UNITED STATES PATENT AND TRADEMARK OFFICE

APPLICATION NO.	FILING DATE	FIRST NAMED INVENTOR	ATTORNEY DOCKET NO.	CONFIRMATION NO.
10/849,697	05/20/2004	Lucretia Sessano	SESSANO ET AL 1	7641
25889	7590	04/06/2007		
WILLIAM COLLARD COLLARD & ROE, P.C. 1077 NORTHERN BOULEVARD ROSLYN, NY 11576			EXAMINER HANSEN, JAMES ORVILLE	
			ART UNIT	PAPER NUMBER
			3637

Office Action Summary

DETAILED ACTION

FIG. 2

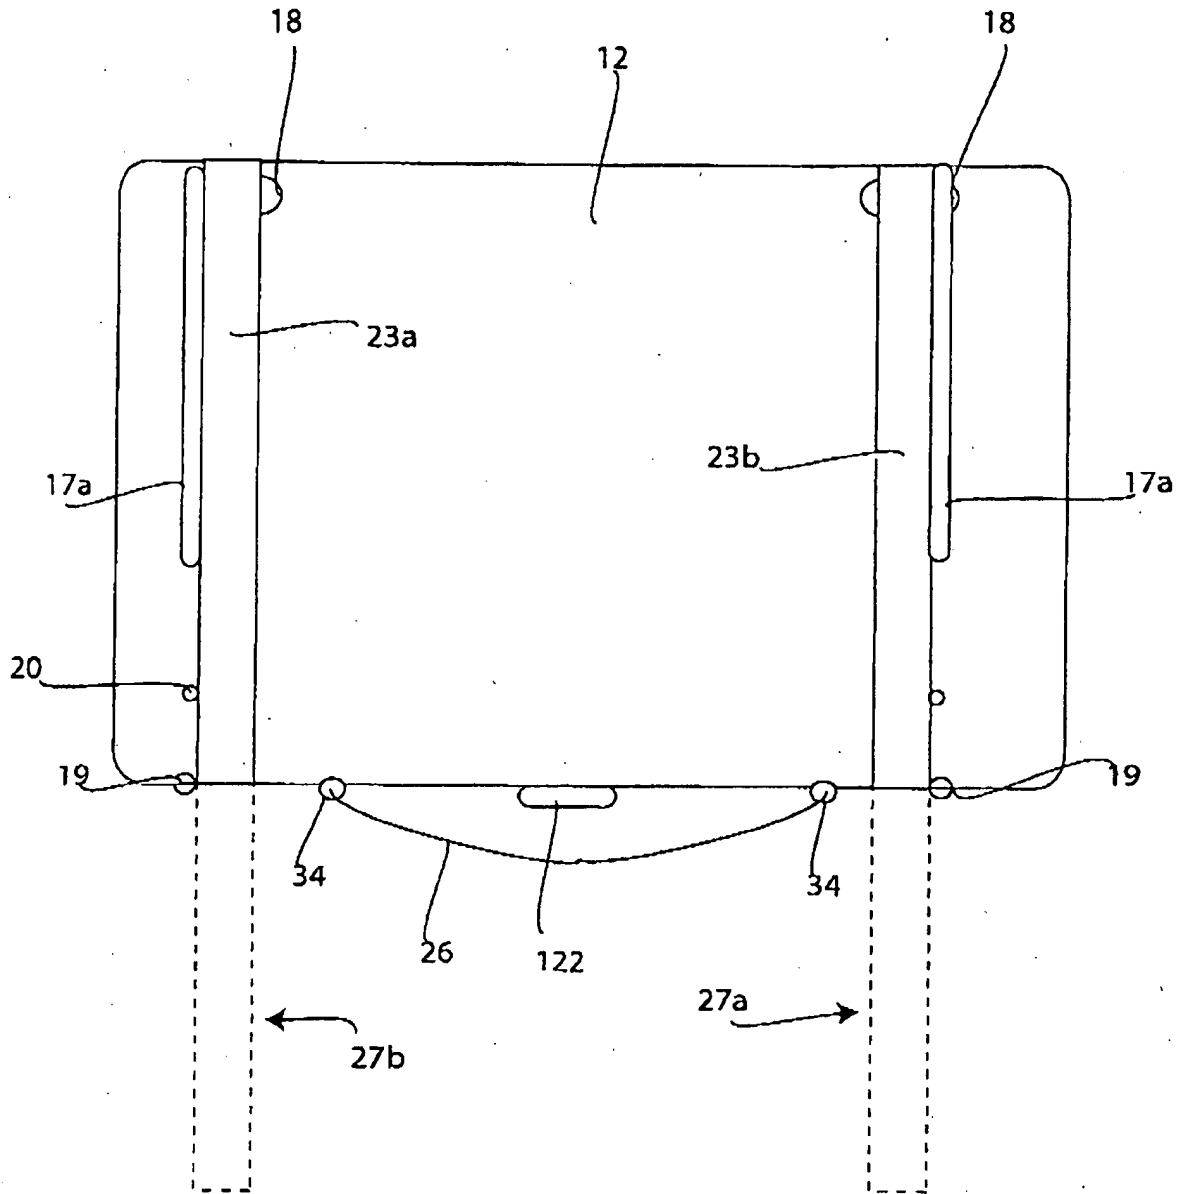
Approved for examination purpose
for 3/30/07

FIG. 3

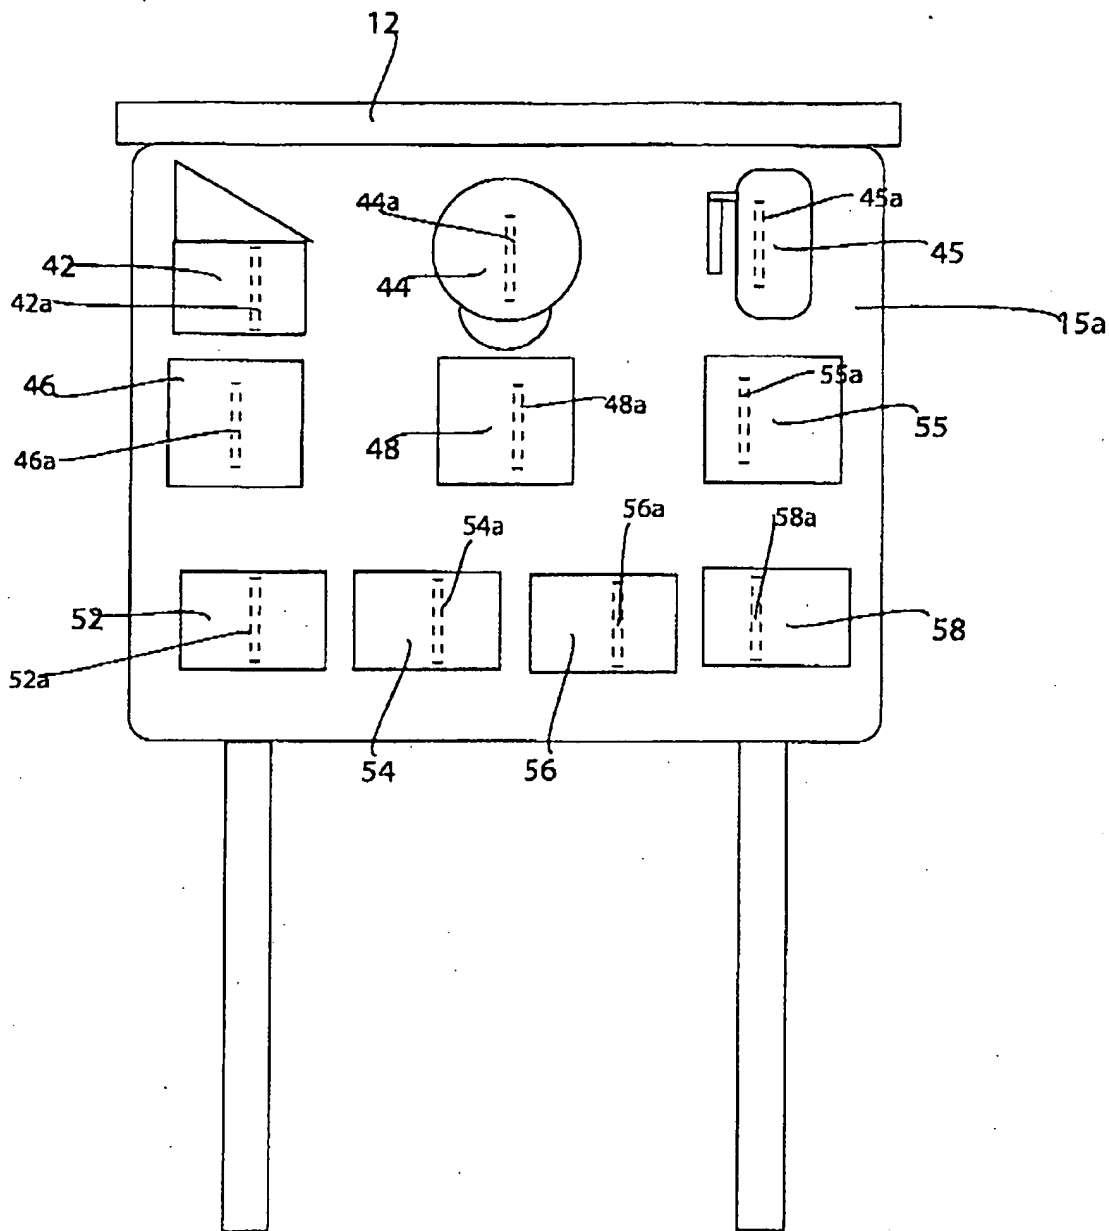
Approved for Examination purposes
Jph 3/30/07
